**TO:** T10 Membership  
**FROM:** Paul A. Suhler, Quantum Corporation  
**DATE:** 2 November 2007  
**SUBJECT:** T10/07-469r0, ADT-2: ADT Over Ethernet (ADToE)

**Figure 12 – Example of shared ADToE socket in an automation device**

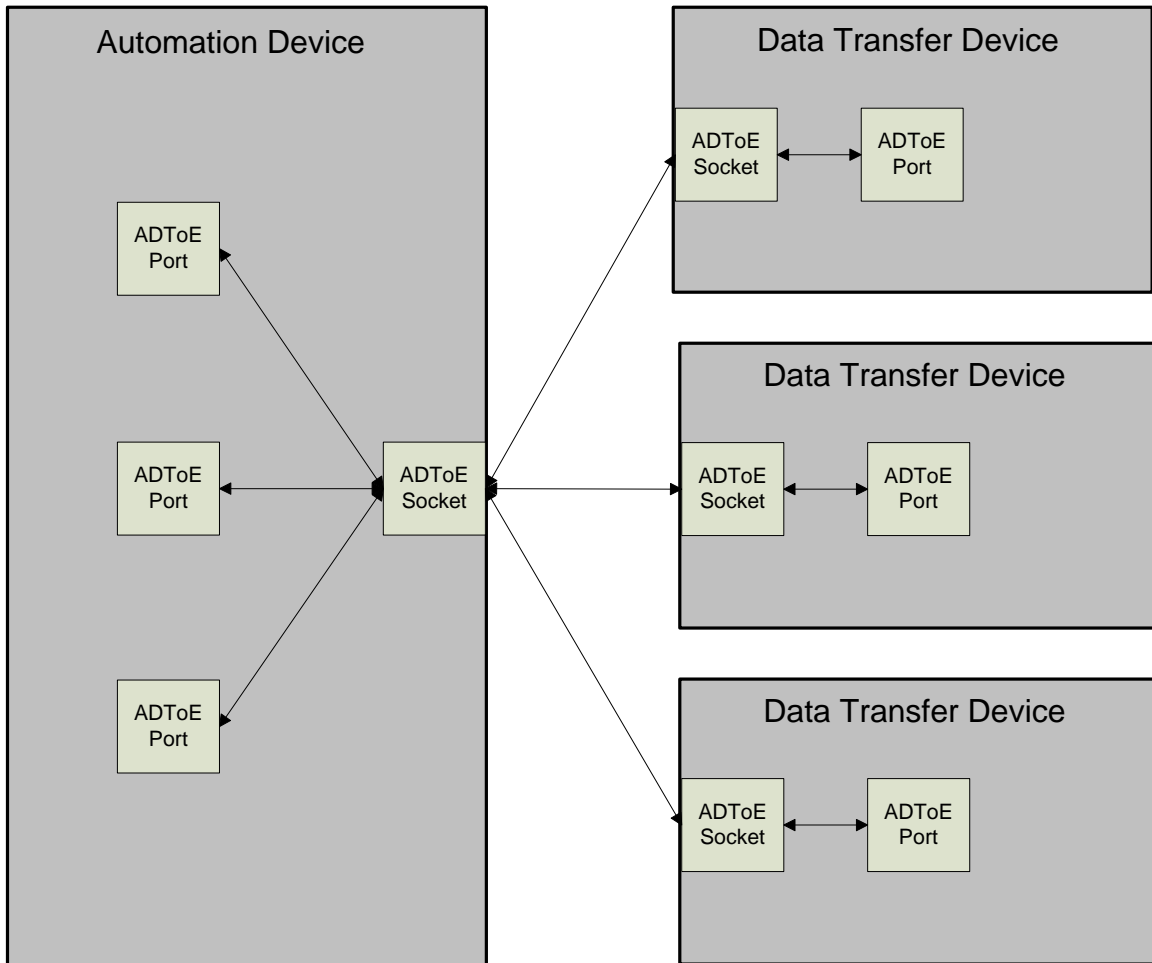
One physical Ethernet port may respond to multiple internet addresses, and thus may contain multiple ADToE sockets, one for each of the internet addresses. If a device (e.g., device A) contains only one ADToE socket (i.e., there is one Ethernet port and it responds to a single internet address) then that ADToE socket may be connected to ADToE sockets in different devices. Each of those ADToE connections connects to a different ADT port in device A. (See Figure 12.)
